CERTIFICATE OF APPROPRIATENESS PLACARD

410 Glenwood Ave

COA-0148-2025

Material and Detail Modifications to Previously-Approved COA

Galleria Elevation

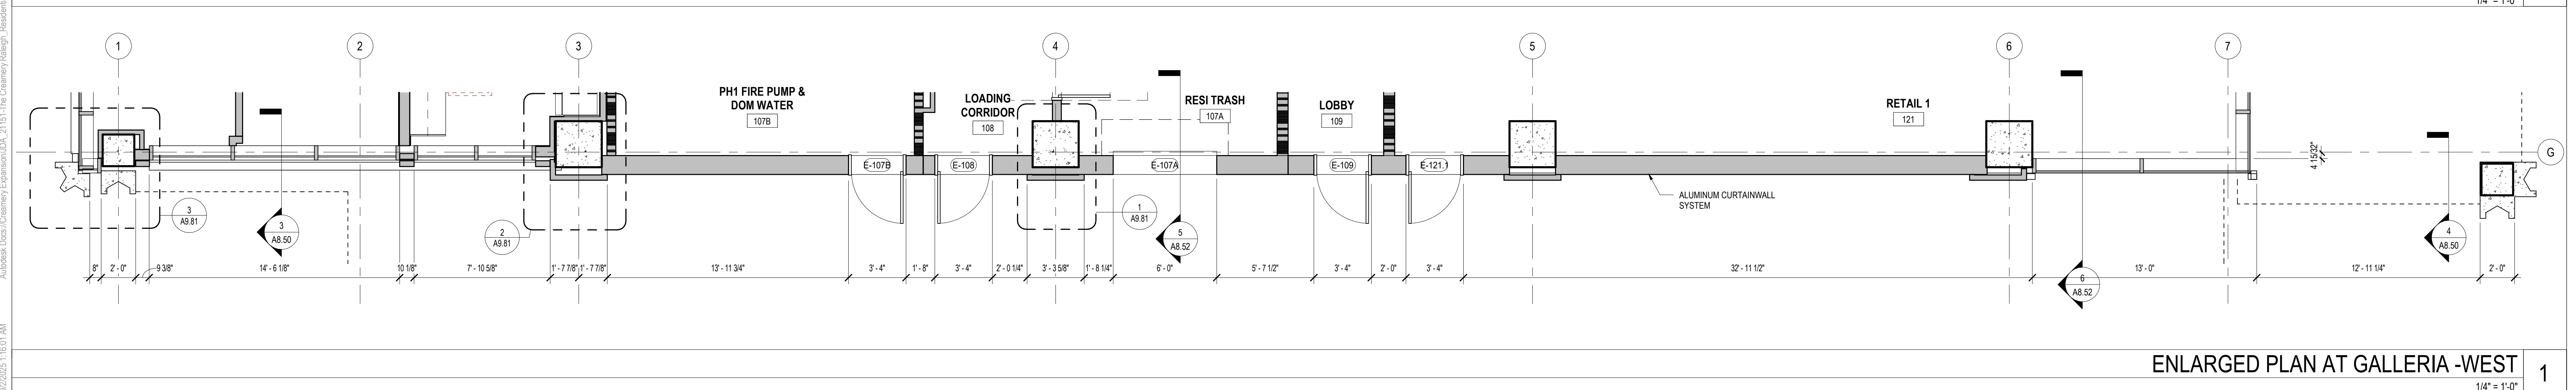
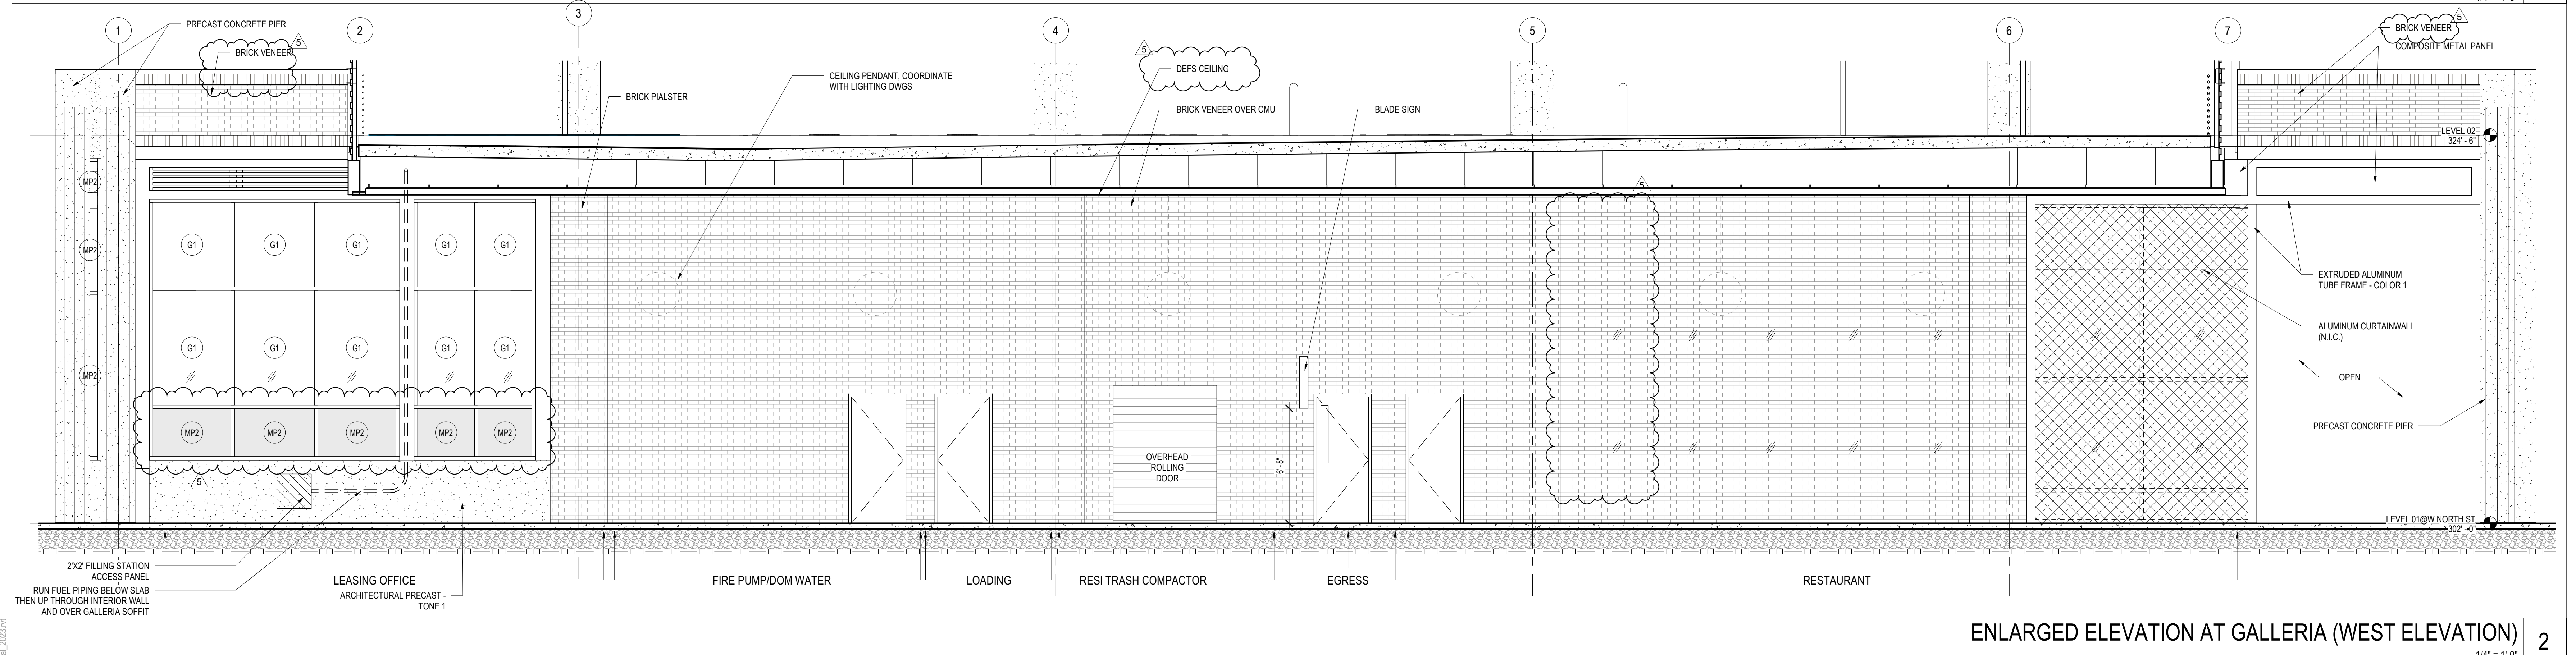
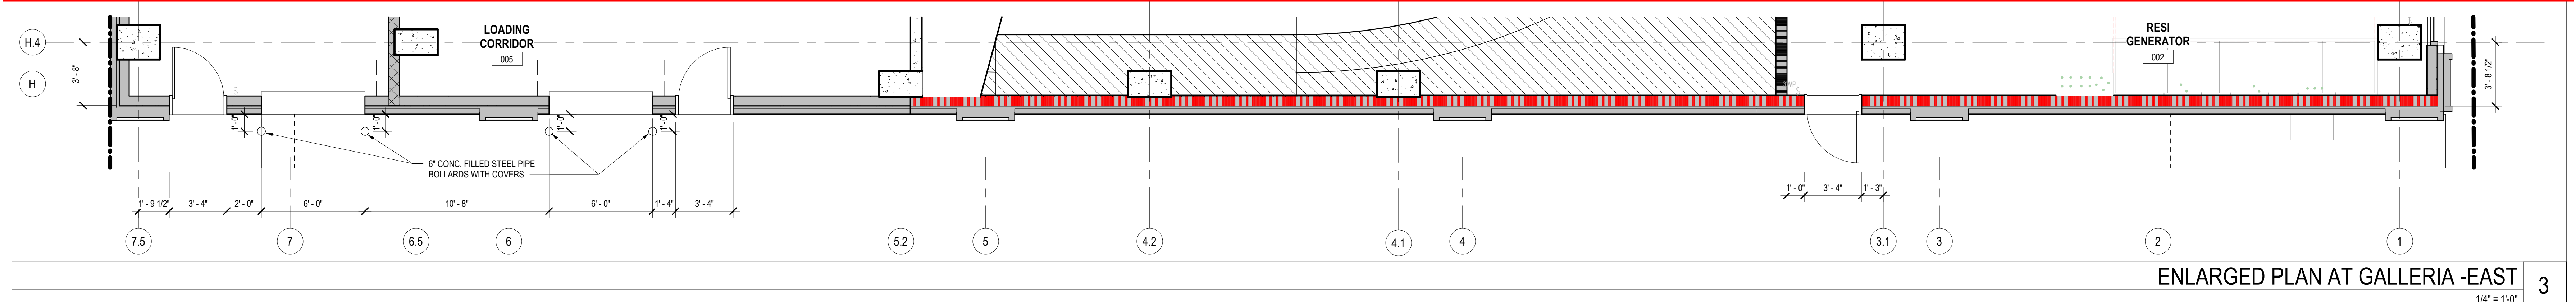
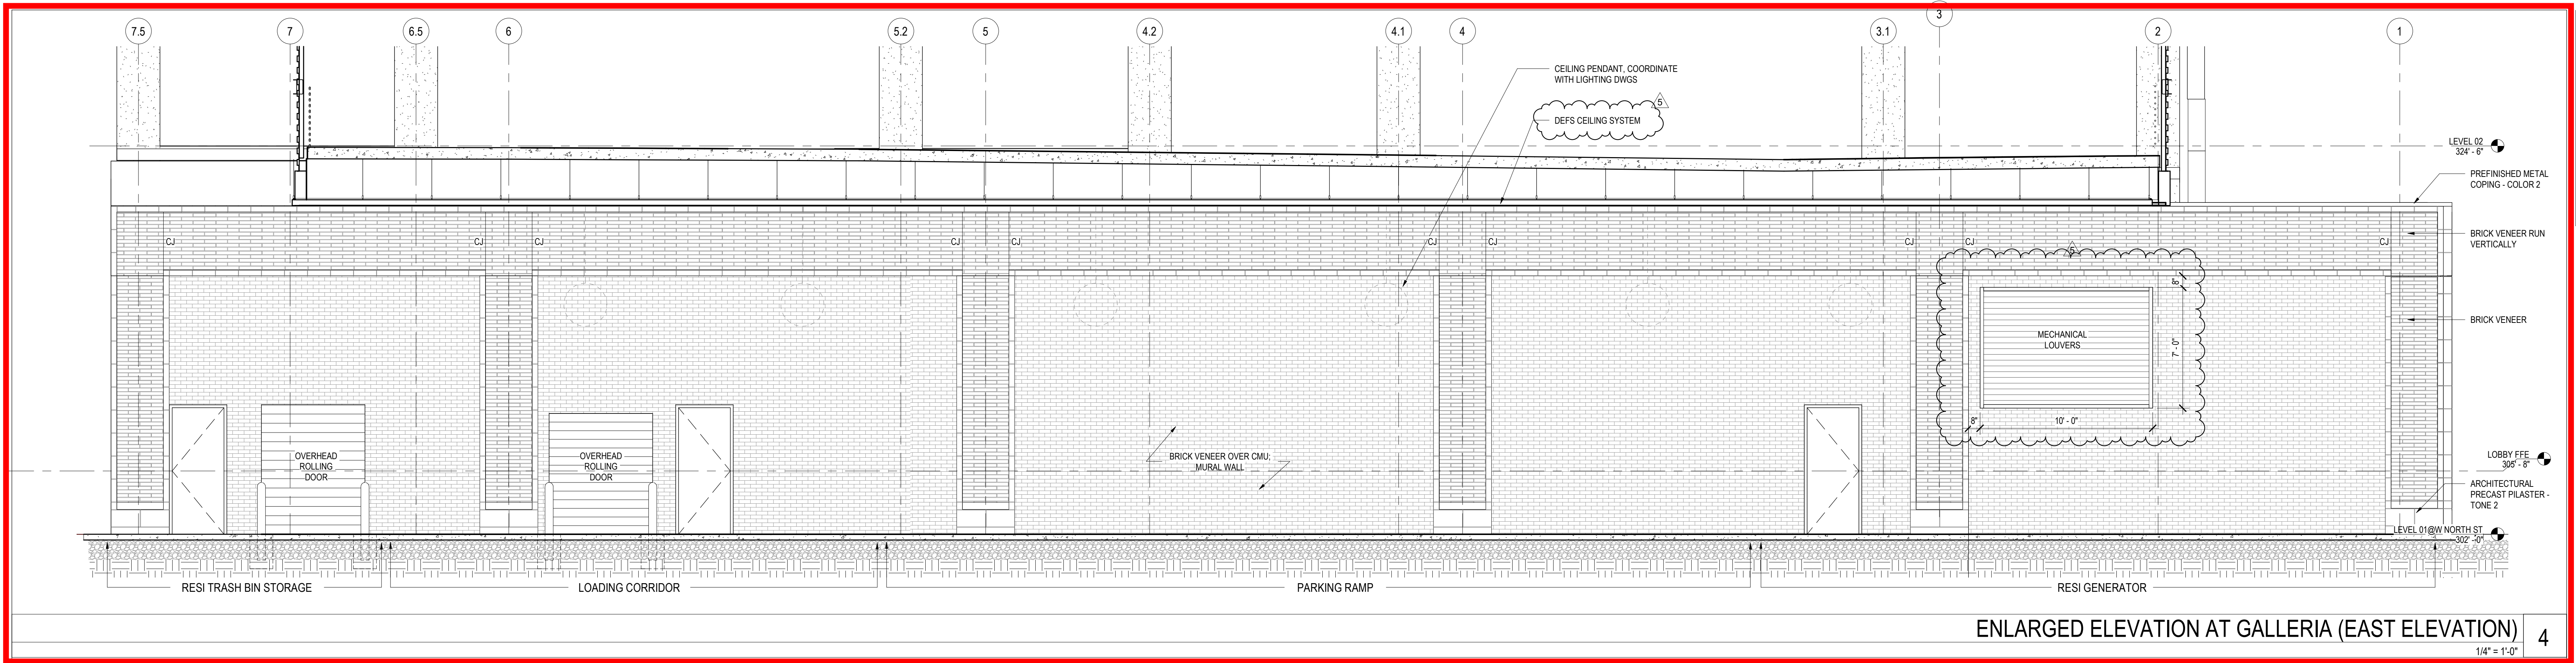
1. To fit the revised ramp for the phased construction (which also eliminates the sloped parking floors in the previously-approved COA), the retail spaces in the galleria have been eliminated due to reduced ceiling heights and are now replaced with service and utility spaces beneath the ramp.

3. The brick and concrete frame and the five associated storefront bay sizes have been slightly adjusted to fit the revised structural grid for the parking deck ramp but remain generally consistent with the previously-approved COA.

4. With the retail removed, the storefronts in these five bays have been replaced with brick infill with man doors, overhead doors, and a mechanical louver to provide access to the building service areas under the ramp. The brick infill will match the brick used at the North Street elevation. The overall composition is generally consistent with the service elevation at the 1997 rear addition to the historic Creamery building.

1. Based on the garage changes, the profiled ceiling in the galleria has been simplified to a flat ceiling.
 - The precast ceiling has been changed to synthetic stucco and will be painted to be similar color and texture to the precast elements on the building.

1. Side-by-side rendered elevations for the previously-approved and currently proposed elevation illustrates these modifications.
2. Architectural drawing 4/A3.73 illustrates the Galleria elevation. Door schedule A11.02 confirms door sizes per Condition #4 of the December 09, 2021 Decision Letter.
3. Architectural drawings 2 and 3/A8.52 illustrate this wall and ceiling sections through the Galleria. Note that 5 and 6/A8.52 (cut through the opposite residential building wall) show the continuation of the ceiling.
4. A graphic material key shows material colors and selections for the building.
Material samples and colors will be delivered to the RHDC office.
